DUANE ARNOLD ENERGY CENTER - ISSUANCE OF AMENDMENT

REGARDING STANDBY LIQUID CONTROL MINIMUM BORON

CONCENTRATION (TAC NO. MB0102)

SAFETY EVALUATION BY THE OFFICE OF NUCLEAR REACTOR REGULATION RELATED TO AMENDMENT NO. 236 TO FACILITY OPERATING LICENSE NO. DPR-49

Figure 3.1.7-1 (page 1 of 1) Sodium Pentaborate Solution Volume Versus Concentration Requirements

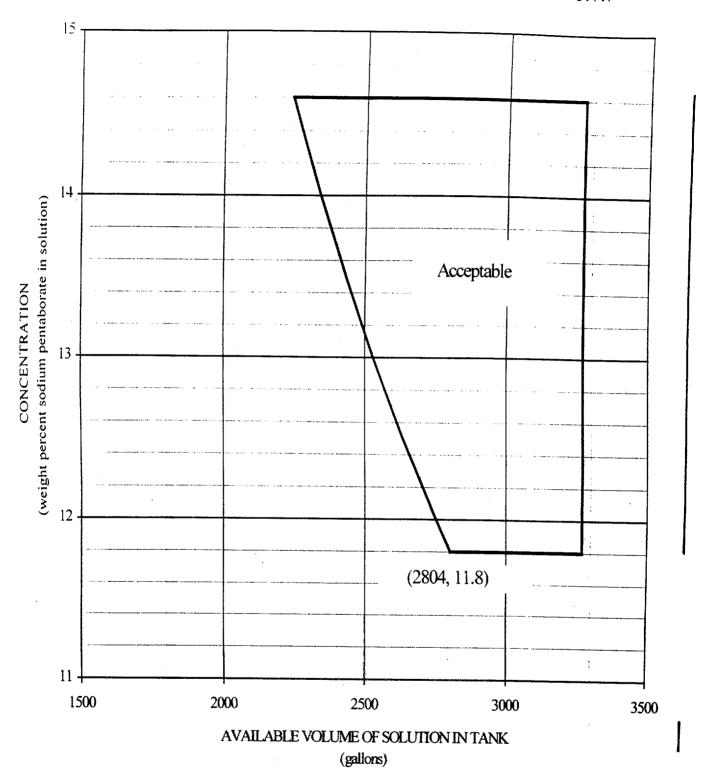
The amendment revises the Standby Liquid Control boron solution requirements in TS Figure 3.1.7-1 to ensure a minimum boron concentration of 660 parts per million in the reactor.

The DAEC TS include surveillance requirement 3.1.7.1 which requires that the available volume of boron solution in the SLC tank be within the limits of TS Figure 3.1.7-1. DAEC TS surveillance requirement 3.1.7.5 requires that the concentration of boron in solution be within the limits of TS Figure 3.1.7-1. The licensee has proposed to modify TS Figure 3.1.7-1 to contain the acceptable volume and concentration values which would result in a minimum boron concentration of 660 ppm consistent with the results of GE's analysis. An additional 25 percent of the quantity of boron required to achieve a minimum boron concentration of 660 ppm in the reactor will also be injected, maintaining the margin which compensates for imperfect mixing and potential leakage in the reactor system.

The licensee has also proposed a change to clarify TS Figure 3.1.7-1. Figure 3.1.7-1 is currently titled "Gross Volume of Solution in Tank." Since the SLC tank outlet is above the bottom of the tank, the gross volume in the tank is not available for injection in the reactor. The licensee has proposed to change the title of Figure 3.1.7-1 to "Available Volume of Solution in the Tank." This change corrects a potential inconsistency in the TS, and is therefore, acceptable.

By letter dated September 19, 2000 (Ref. 1), the Nuclear Management Company, LLC (the licensee) submitted a request to amend the technical specifications (TS) for the Duane Arnold Energy Center (DAEC). The proposed TS amendment changes the standby liquid control system boron solution requirements to ensure a minimum boron concentration of 660 ppm in the reactor.

The design of the DAEC SLC system complies with the requirements of 10 CFR 50.62 for anticipated transients without scram (ATWS). The current DAEC SLC system boron concentration requirement bounds that required by 10 CFR 50.62, and the SLC system will continue to comply with the requirements of 10 CFR 50.62 when the minimum SLC boron concentration is increased to 660 ppm.

The staff has reviewed the licensee's proposed changes to TS Figure 3.1.7-1 and the associated Bases section related to the standby liquid control boron solution requirements. Based on the review, the staff concludes that the proposed TS changes are acceptable.
